# B I D A D D E N D U M 0 2

This Addendum consists of the following information:

**HARRISON RECREATION & COMMUNITY CENTER**

New Construction - Phase 2  
Town / Village of Harrison  
270 Harrison Avenue  
Harrison, NY 10528

**1 ELECTRICAL ROOF PLAN**  
SCALE: 1/8" = 1'-0"

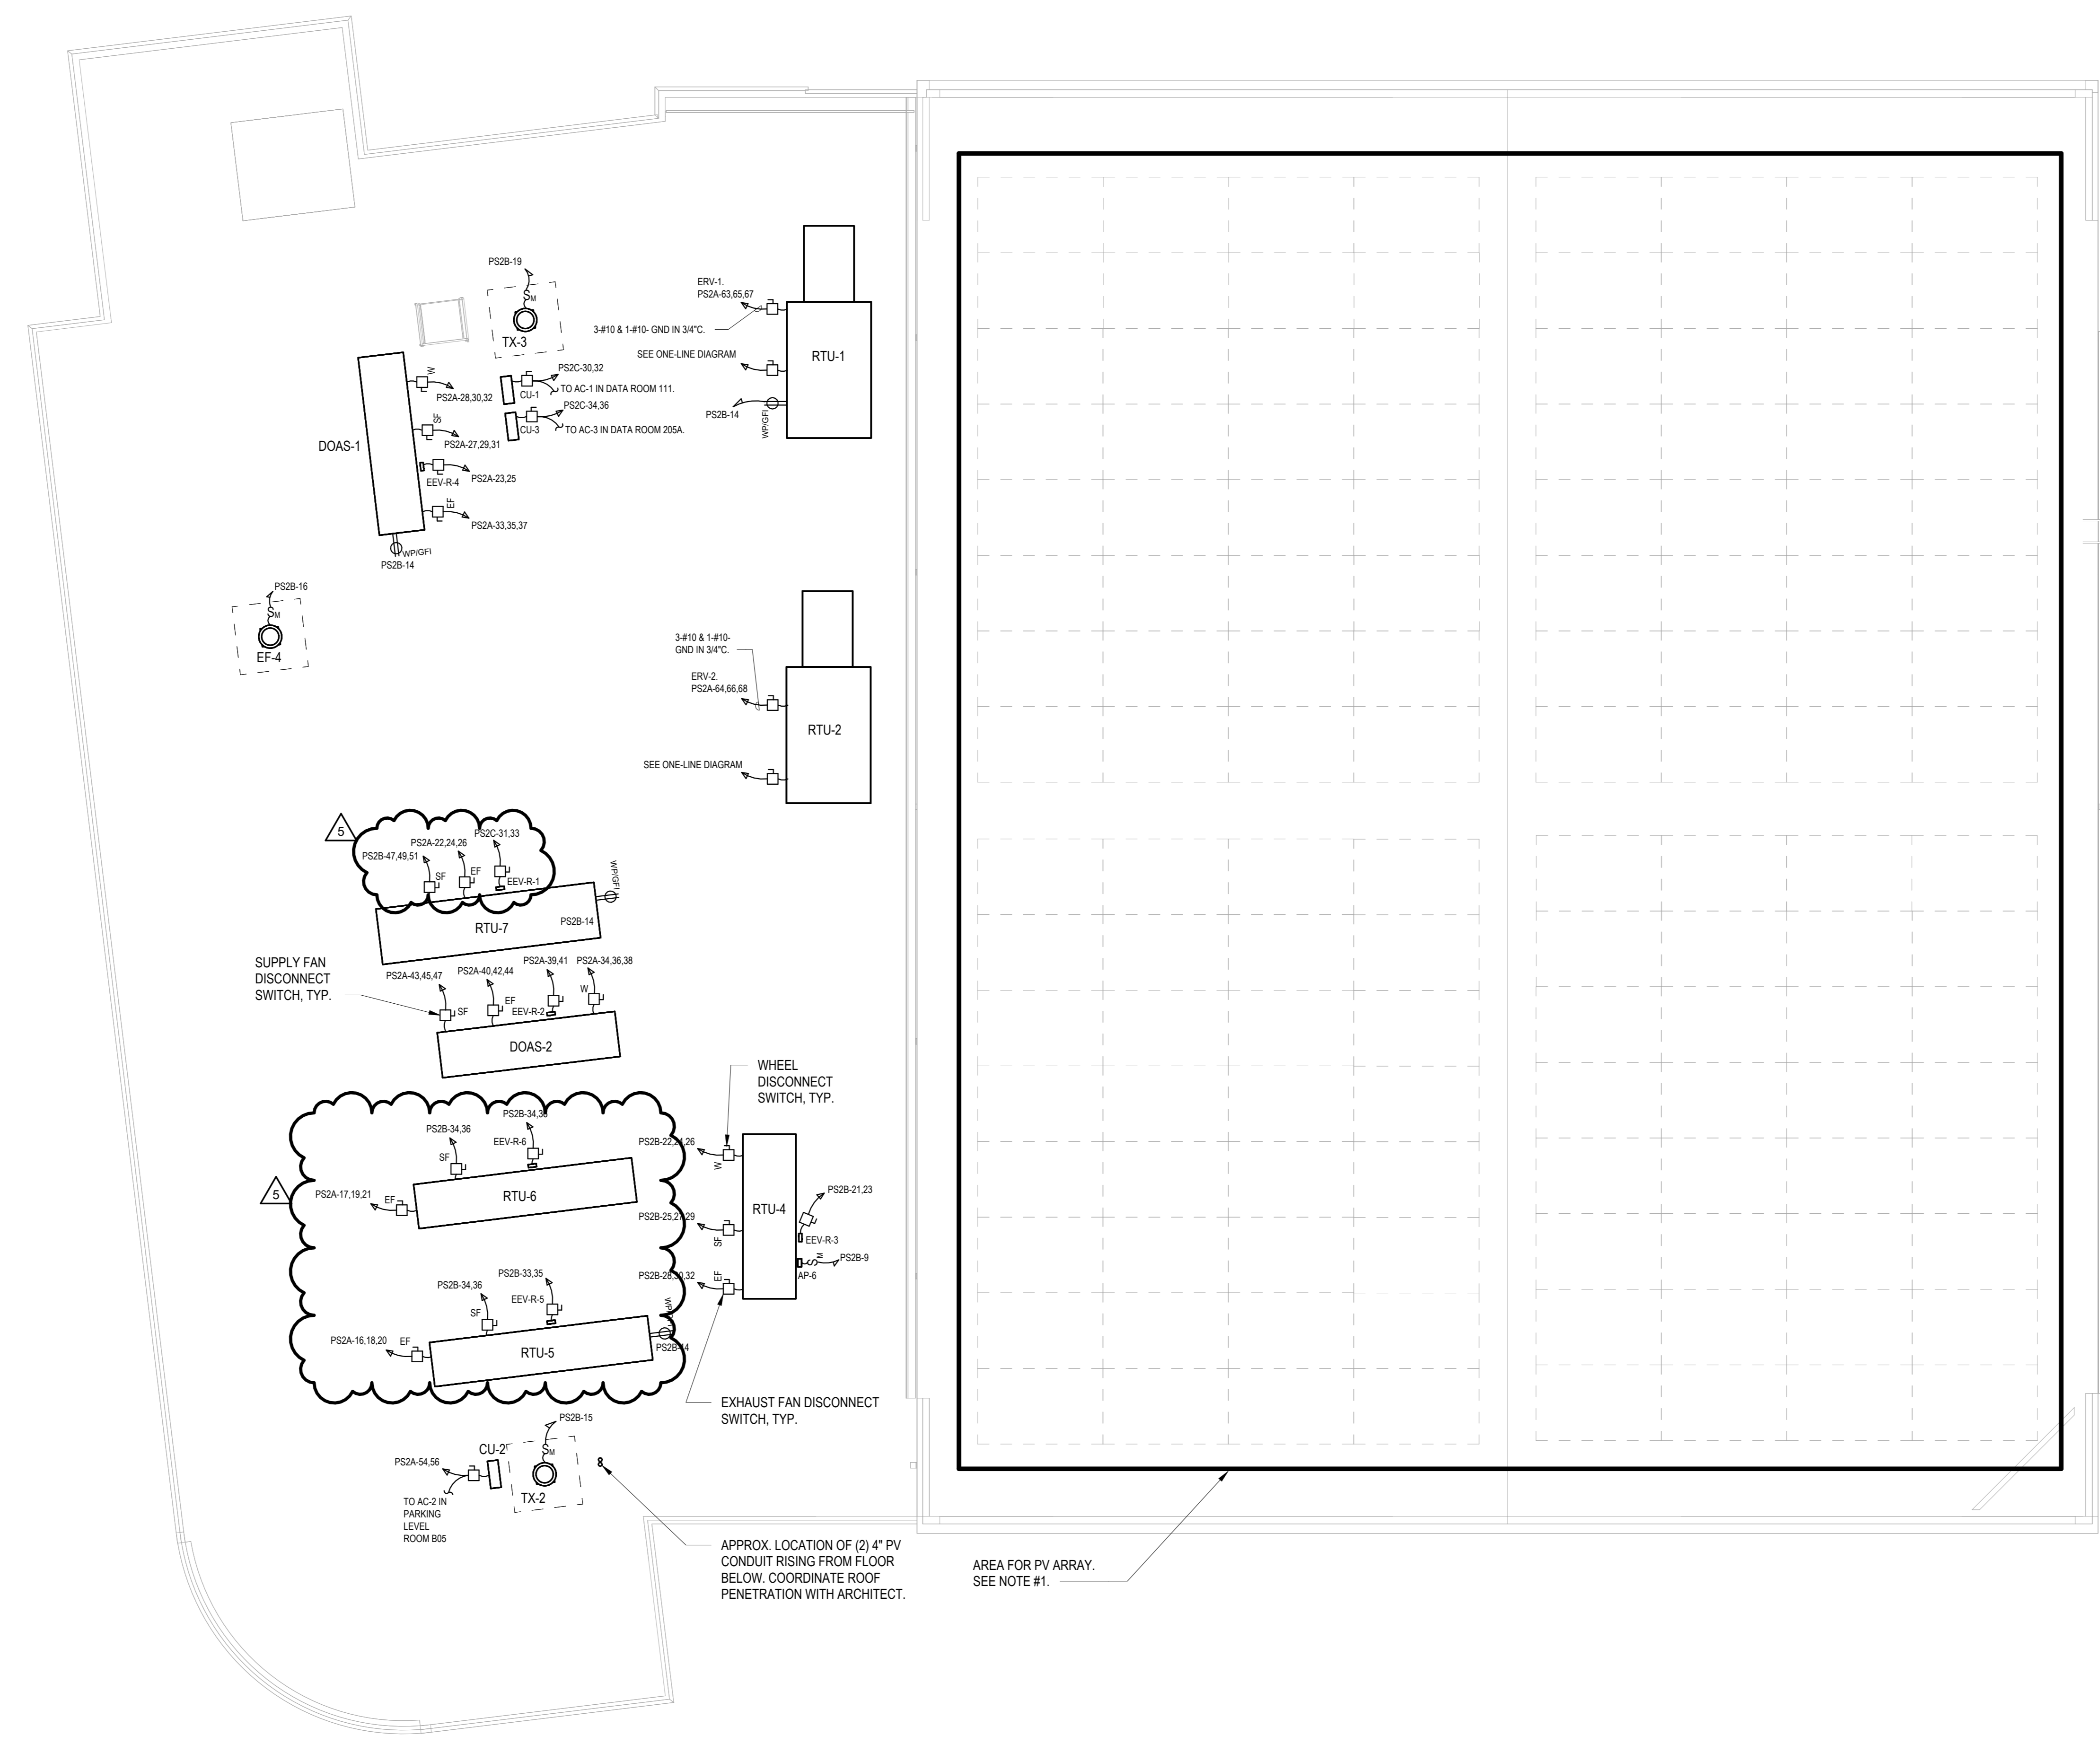
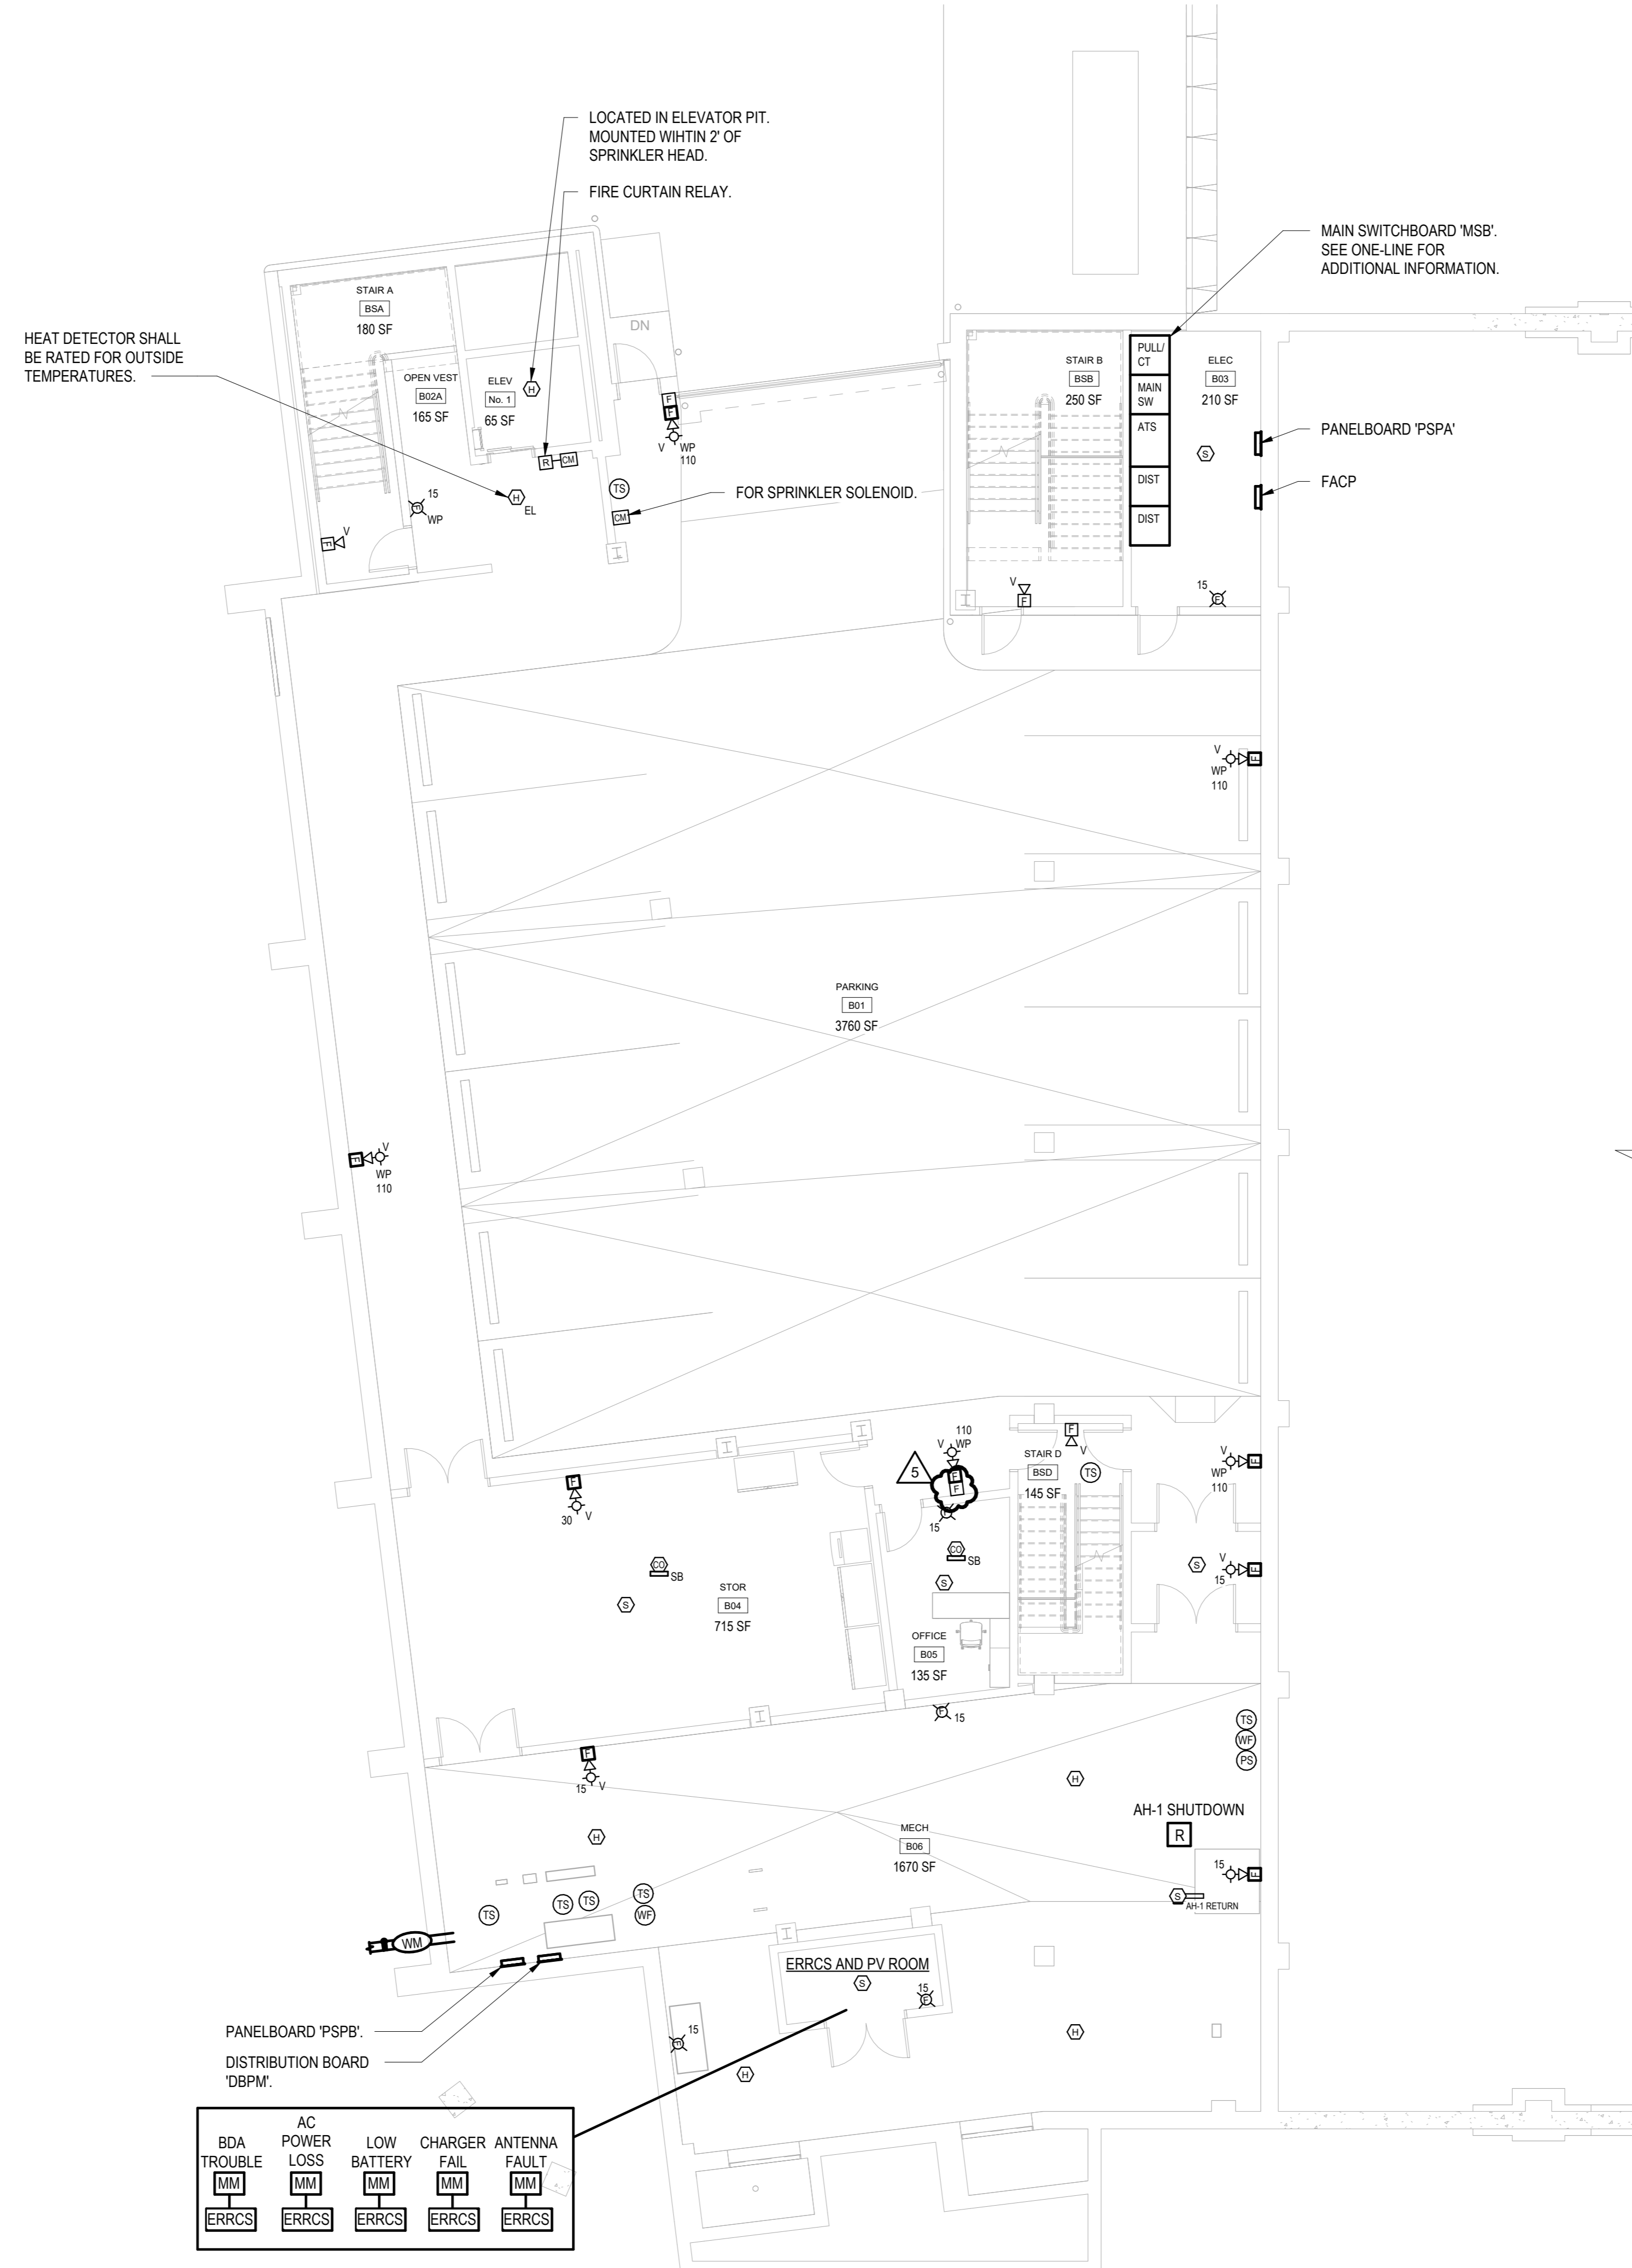
20. Q: Please provide a guideline specification for the PV Array.

A: The PV Array is Not In Contract. Contractor to provide infrastructure only per Electrical Drawings.
